Title: **Safety Recall NHTSA #19V-740 Retainer, Spindle Nut**

TSB - 013

IMPORTANT SAFETY RECALL 19V-740

Part 573 Safety Recall Report

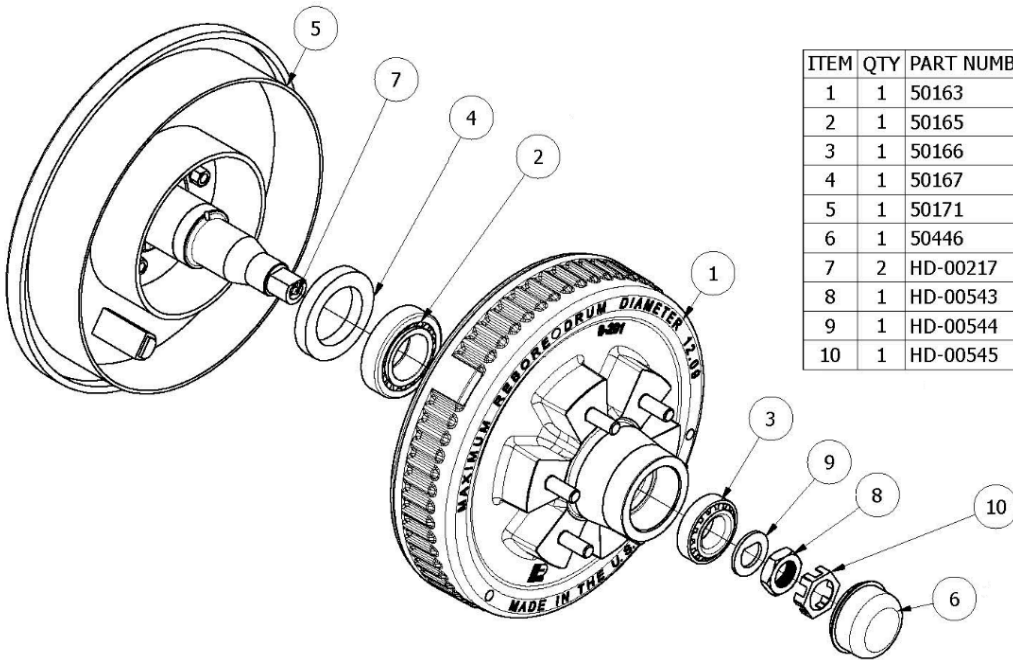
Why is your Vehicle being recalled? These units have a condition in which a safety retainer clip may be missing from the spindle nut. If the clip is missing, over time the spindle nut may loosen and allow the hub and wheel to fall without warning. If the spindle nut loosens or falls off, the wheel may come off the axle assembly, increasing the risk of a crash

Visual inspection for retainer clip *Note: wheel's do not need to be removed*

1. Remove the wheels center cap and then the rubber cap from the dust cover
 - Use a flat tip screwdriver or equivalent tool as shown below
2. Visually verify that the retainer clip is installed
3. Reinstall rubber cap and wheel center cap

What will we do? Voyager Industries will supply at no charge, any missing safety retainer clips. These clips are easily installed with instructions provided with the clips. If you are uncomfortable installing these clips, please contact us and we will arrange for this repair at your location. The repair will take less than 30 minutes.
